**PLEASANT PRAIRIE PLAN COMMISSION MEETING  
VILLAGE HALL AUDITORIUM  
9915 39<sup>th</sup> AVENUE  
PLEASANT PRAIRIE, WISCONSIN  
6:00 P.M.  
OCTOBER 8, 2012**

**AGENDA**

SHEET NUMBER:  
**C-1.0**

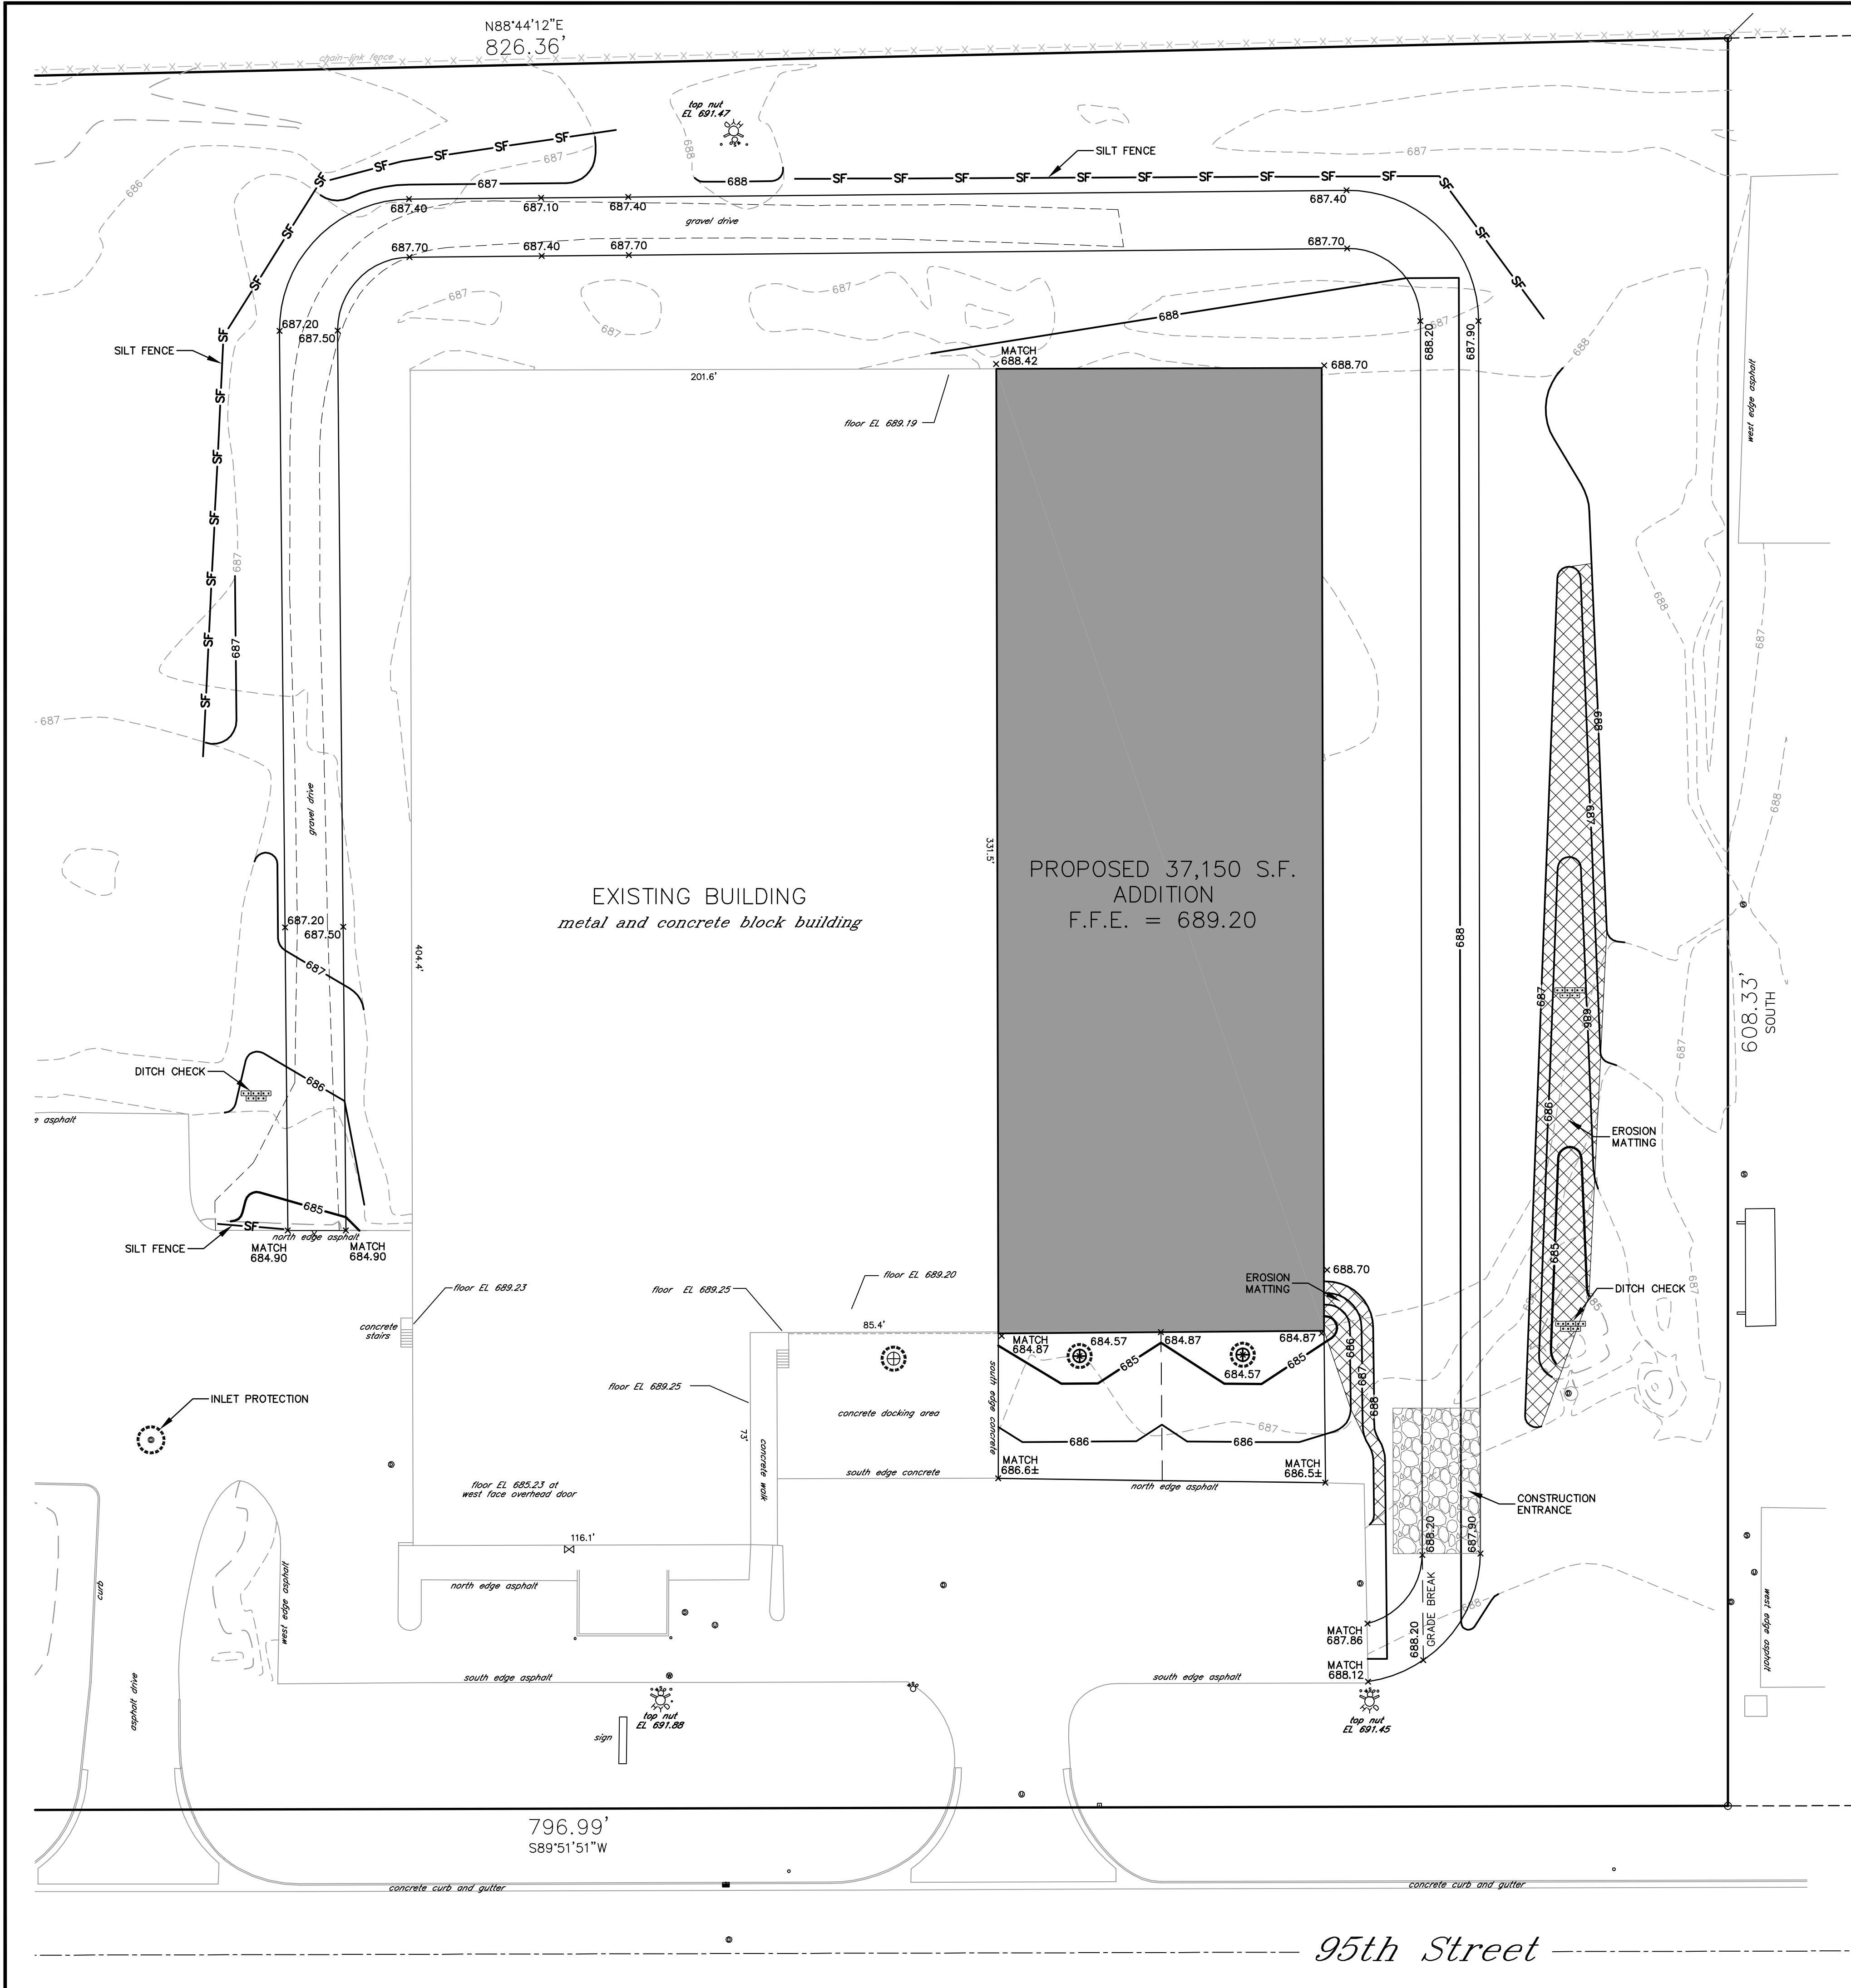
- l. Since CSW plans to sell its eastern 95 feet of property to Fair Oaks Farms, Plan Sheet C101 should label "Fair Oaks Farms" as the facility to the east.
